Transport Response

Dover Road, Walmer, Kent

Iceni Projects Limited on behalf
of Gladman Developments

1. RESPONSE TO 13TH JULY 2017 HIGHWAY COMMENTS

**A1. DRAWING OF REFUSE TRUCK USED IN APPROVED
APPLICATION DOV/14/00361**

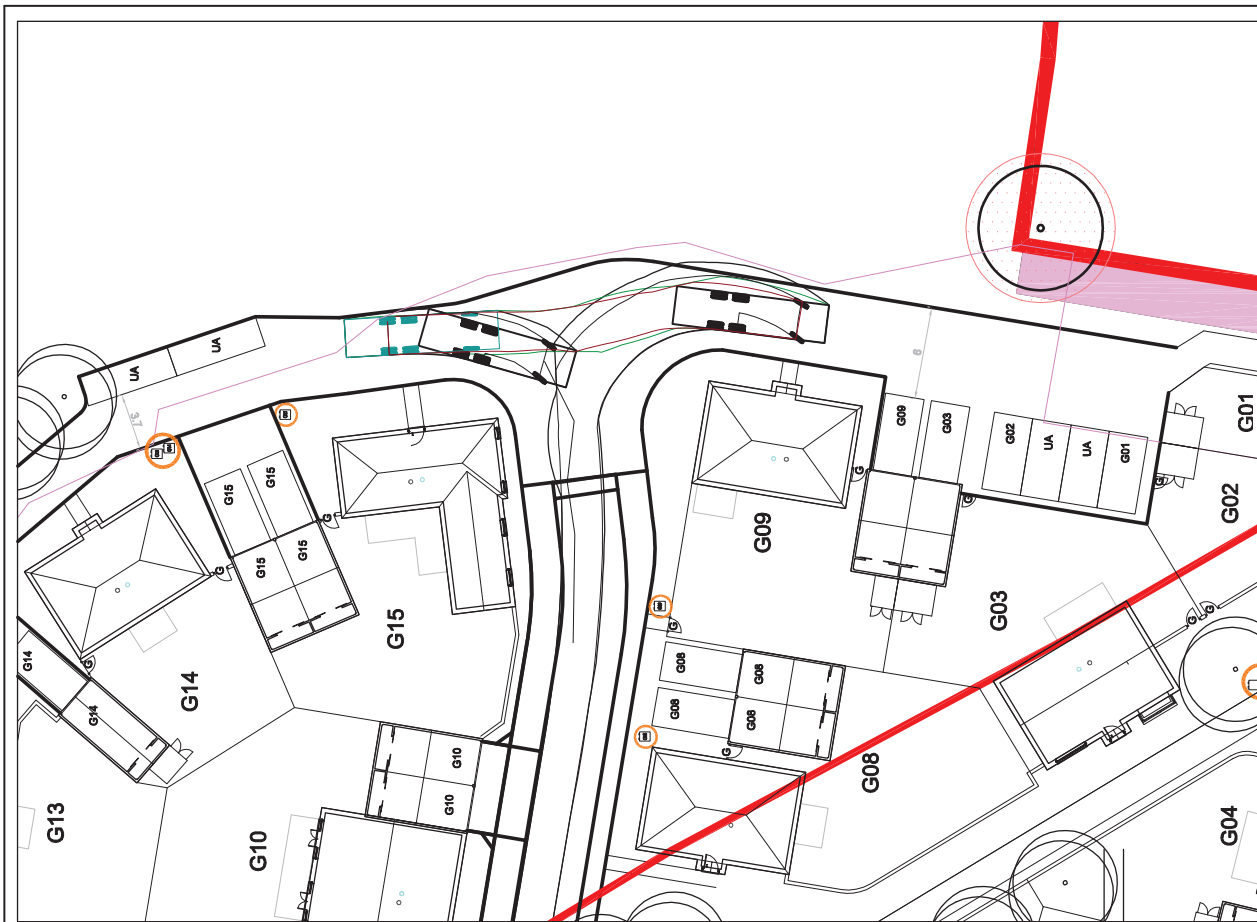
It appears a refuse vehicle turning right out of the access will overrun and overhang the proposed island and associated waiting point for pedestrians in the existing footway, so the island or access point will presumably need to be relocated to resolve this. The swept path diagram is also not based on the proposed highway layout including the footway widening.

- 1.2 At the time of writing the Transport Assessment (TA), a 4 axle refuse truck was used to track entering and exiting the site, with only a small amount of body overhang. However, it was established that from the permitted development on Station Road that a 9.8 metre 3 axle refuse truck was used, the relevant sketch from the TA of the application DOV/14/00361 is shown in **Appendix A1**. As this scheme access and internal layout has been approved at the planning committee there is the precedent to use this vehicle for our assessment. Re-tracking of the access has been conducted using the approved vehicle with the drawing demonstrating the vehicle is able to manoeuvre in and out of the site with the proposed widening of the footway on the north side of Dover Road to 1.8 metres. **Appendix A2** of this note shows that the 9.8 metre refuse truck is acceptable and shows no overhang on the pedestrian island.

Swept Path Analysis

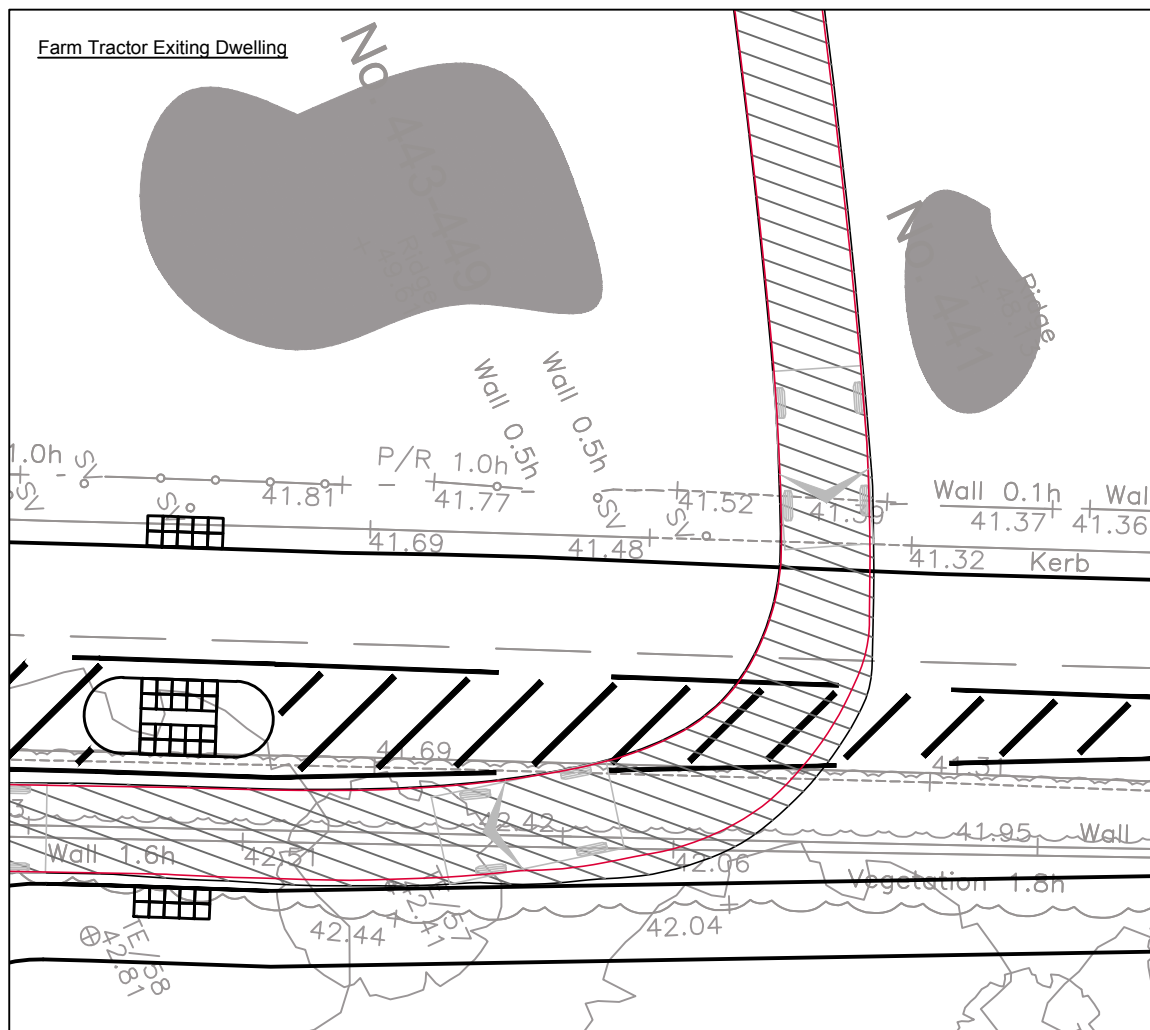
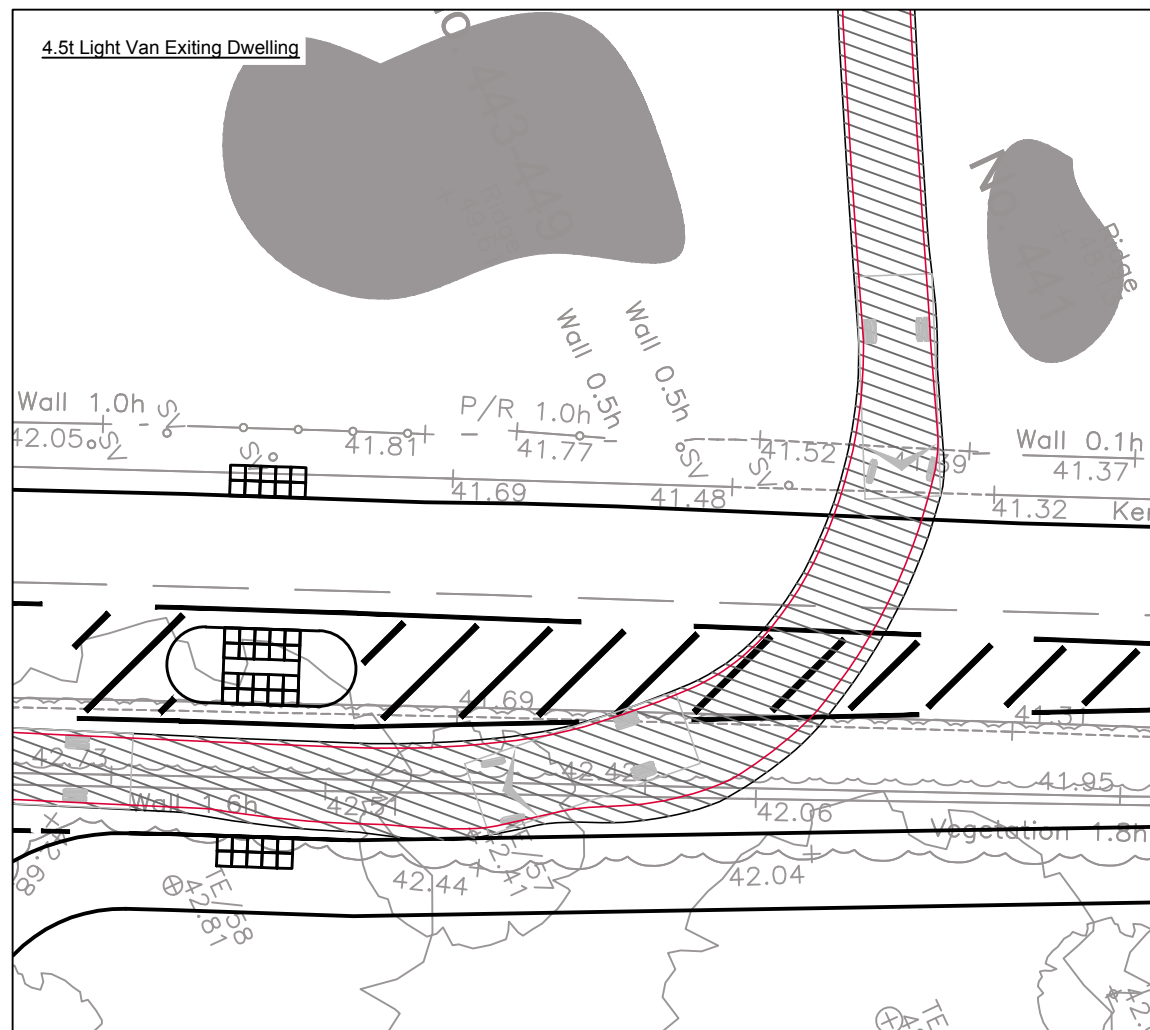
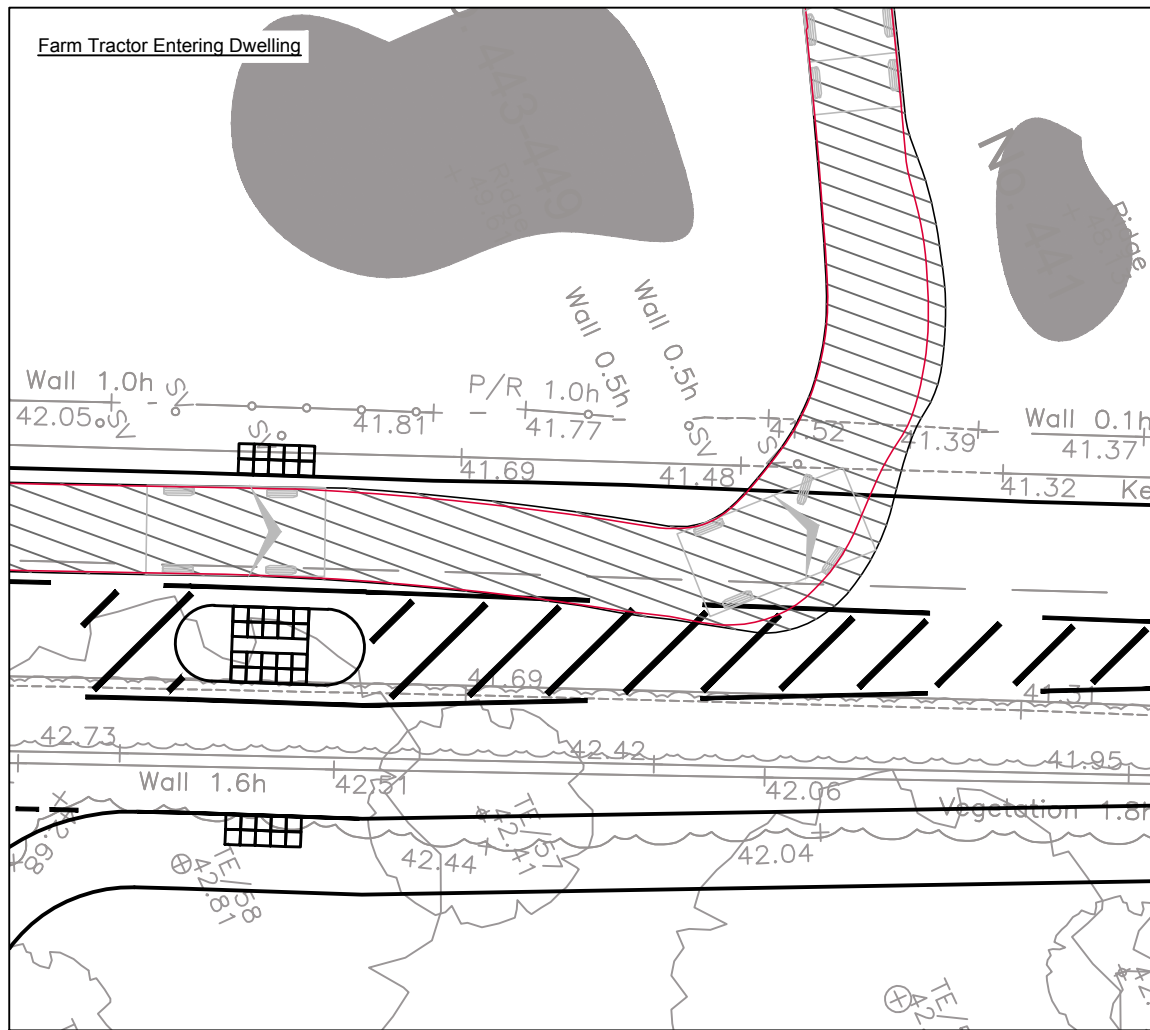
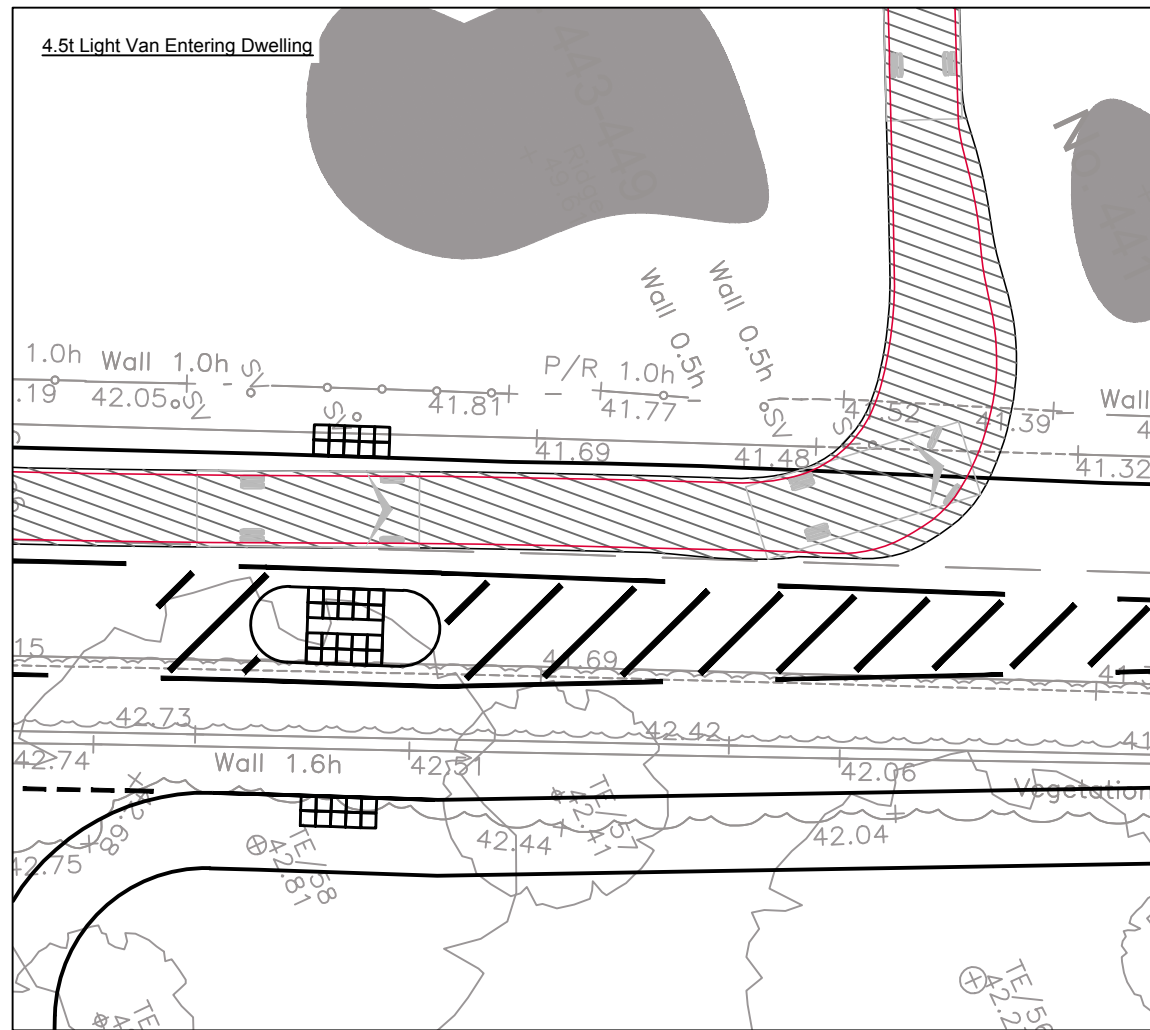
The swept path drawing for the existing access between numbers 441 and 443 Dover Road shows a van making the manoeuvres but it is not clear that this is the largest vehicle using this access. Clarification is required on this point as the access appears to lead to agricultural land which may require access for larger vehicles.

- 1.4 There will be no change between the existing and the proposed access between numbers 441 and 443 Dover Road, which could be used for vehicles. We have re-tracked the access demonstrating that a farm tractor and van can still access. It should be noted that the access between 441 and 443 Dover Road is approximately 14 metres from the proposed new pedestrian crossing. This tracking is shown at **Appendix A2**.
